SECTION 000001 – ADDENDUM NUMBER 1

DATE: February 29, 2024

RE: West Tatnuck ES Cafetorium Flooring Replacement

A-111

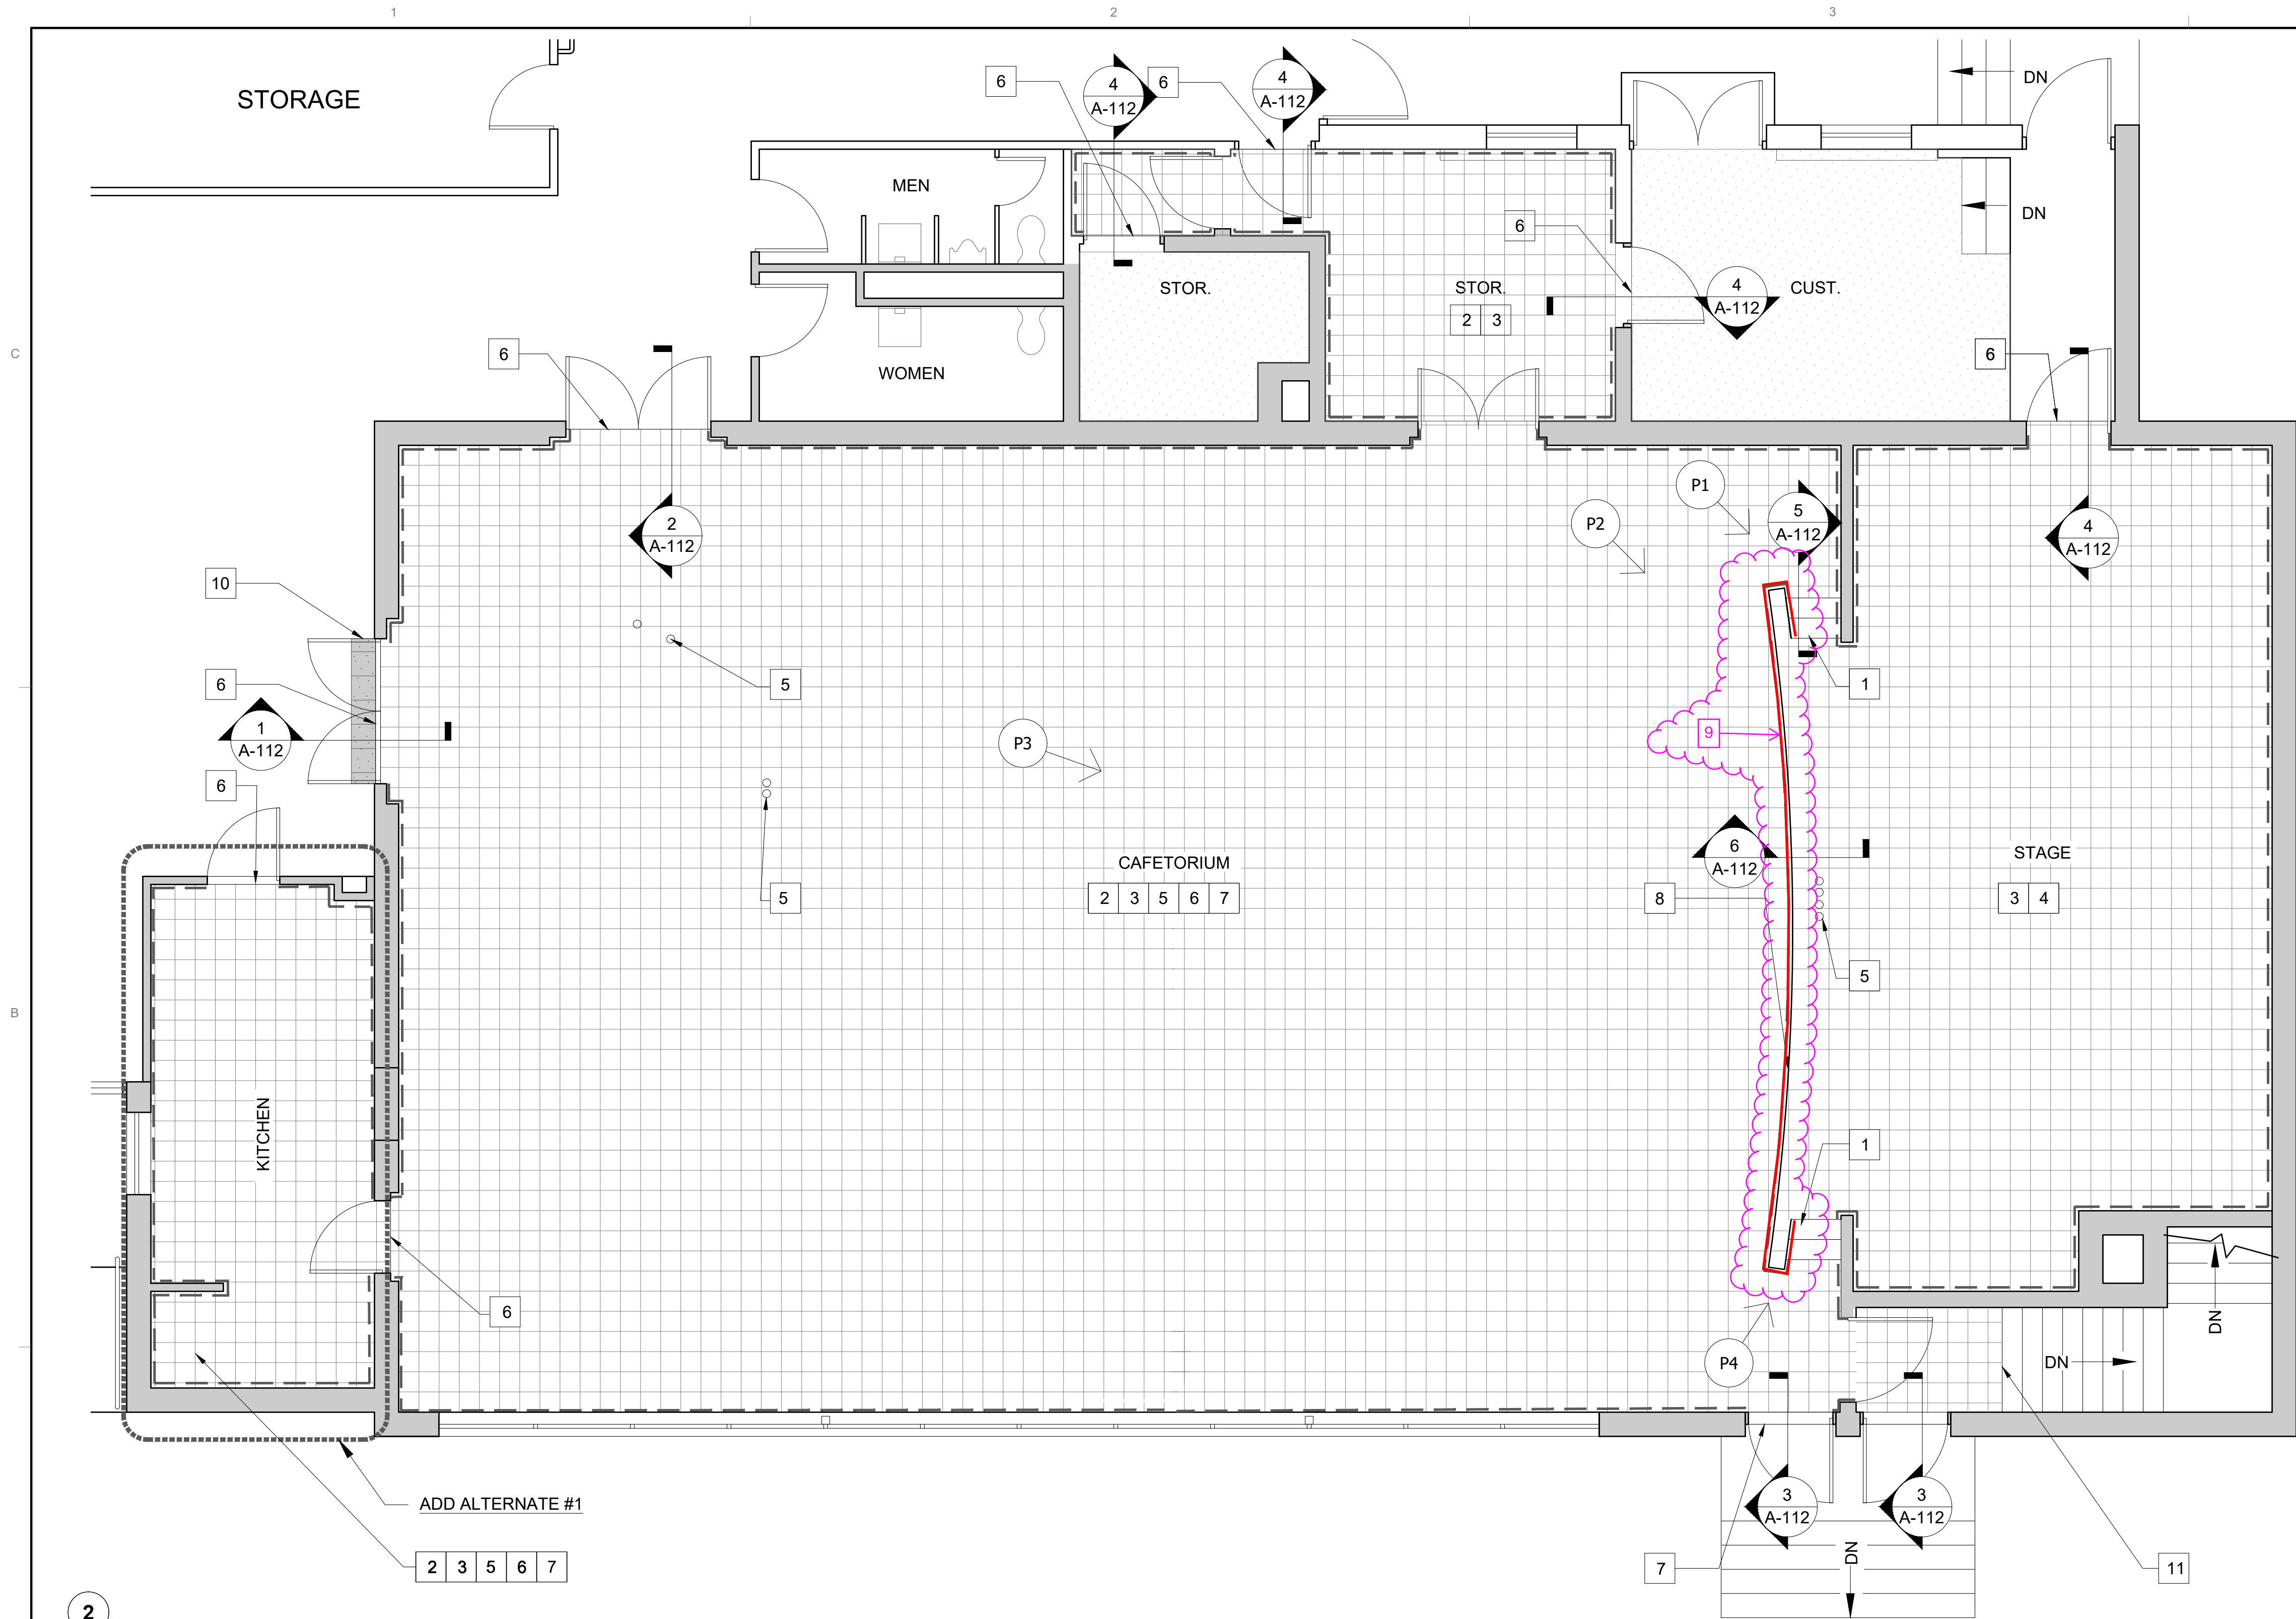
PART 3 - DRAWINGS - Revised drawing A-111, dated 02/29/24, attached.

2. Drawing A-111 lists a number 9 in the New Work key notes and yet there is no number 9 specific to the stage on the drawing. Is this a requirement of the Bid and if so, what is the extent of the wall painting?

Refer to the attached revised drawing A-111 for clarification.

- 1x8 CELLULAR PVC TRIM PAINTED AT EDGE OF STAGE. COLOR TO BE SELECTED BY OWNER
- PAINT EXISTING STAGE WALL-COLOR TO BE SELECTED BY OWNER. CLEAN, PATCH, AND REPAIR EXISTING WALL TO ACCEPT NEW PAINTED FINISH.
